UNITED STATES PATENT AND TRADEMARK OFFICE

APPLICATION NO.	FILING DATE	FIRST NAMED INVENTOR	ATTORNEY DOCKET NO.	CONFIRMATION NO.
10/782,385	02/18/2004	Satoshi Mizutani	20050/0200895-US0	3573

Office Action Summary	Application No. 10/782,385	Applicant(s) MIZUTANI ET AL.	
	Examiner MICHAEL G. BOGART	Art Unit 3761

DETAILED ACTION

FIG. 18

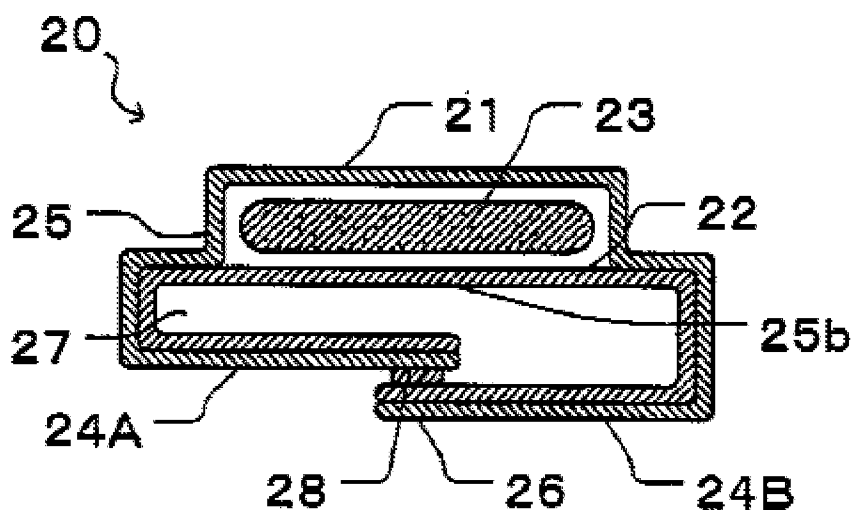
Regarding claim 1, Mizutani teaches an interlabial pad (20) comprising:

a first sheet (21) forming a surface side sheet configured contacting a body, the first sheet (21) having a permeable property for liquid;

a second sheet (22) independent from the first sheet (21) and forming a back face side sheet configured to be positioned away from the body, the second sheet (22) including a plurality of sheet pieces (24A, 24B), each partially overlapping another sheet piece;

an absorbent body (23) for absorbing liquid, the absorbent body (23) being disposed between the surface side sheet (21) and the back face side sheet (22);

a junction joining the surface side sheet (21) and the back face side sheet (22) at a peripheral edge of the absorbent body (23), the absorbent body (23) being enclosed thereby between the surface side sheet (21) and the backface side sheet (22);

at least one seam part (26) of the second sheet (22) formed by overlapping the plurality of sheet pieces (24A, 24B) over one another, the seam part (26) including:

a longitudinal seam part (26) extending in a longitudinal direction over a length of the interlabial pad (20), crossing over the second sheet (22) from an edge to another edge of the second sheet (22) and an adhesive agent (28) applied between the sheet pieces (24A, 24B) at the longitudinal seam part (26) along a longitudinal central line along the longitudinal direction, wherein one of the plurality of the sheet pieces (24B), which overlaps another one of the sheet pieces (24A) at the longitudinal seam part (26) and which covers a side of the other sheet piece (24A) that is closest to the longitudinal central line of the interlabial pad (20), is positioned at the

absorbent body (23) side of the second sheet (22), and wherein the sheet pieces (24A, 24B) are each formed of either a water disintegrable material or a biodegradable material to enable separation of the second sheet (22) along the longitudinal seam part and along the junction joining the surface side sheet (21) and the back face side sheet (21) so that the second sheet may be dispersed into the plurality of sheet pieces and into the sheet pieces (24A, 24B) when discarded by flushing (§s 0074 & 0234).

Regarding claims 9 and 20, Mizutani teaches that the back face side sheet (22) is made uneven at least at the surface opposite the absorbent body (23) side (see fig, 18, *supra*).

FIG. 30

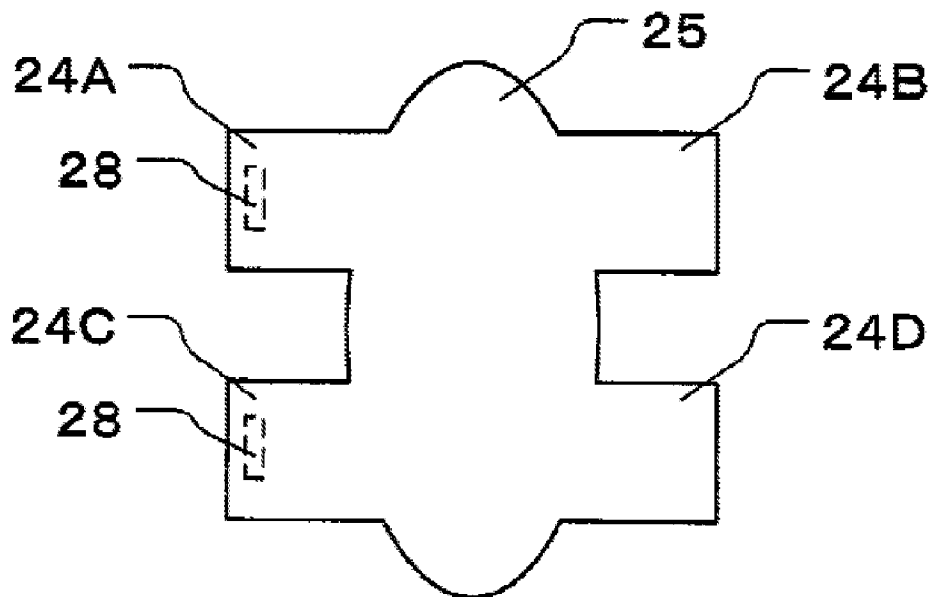
Regarding claims 6 and 23, Mizutani teaches a lateral seam part (25) and a sheet piece (24A) overlapping a sheet piece (24B) at the seam part (see fig. 30, *infra*). Regarding the functional limitations of the claim, apparatus claims must be structurally distinguishable over the prior art. MPEP § 2114. The device of Mizutani can be folded in the claimed manner.

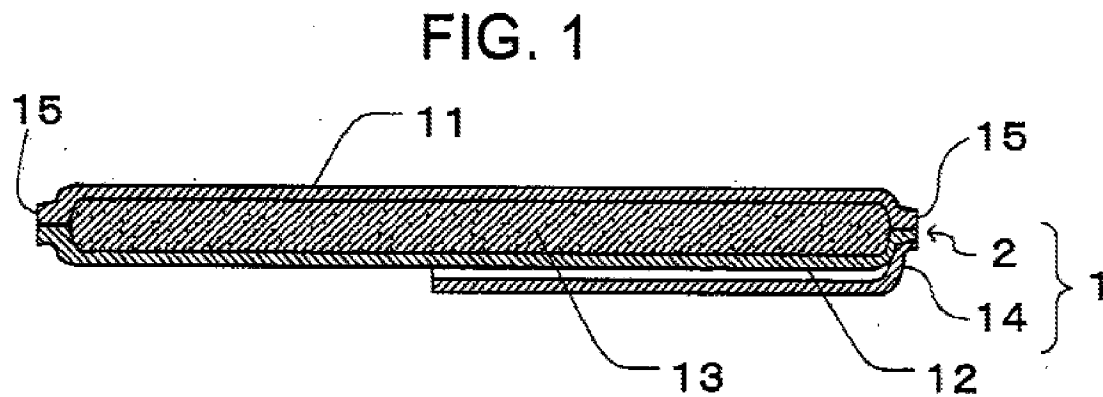
Regarding claim 27, Mizutani teaches a mini sheet piece (14) attached at the junction (2) of sheets (11) and (12)(see fig. 1, *infra*).
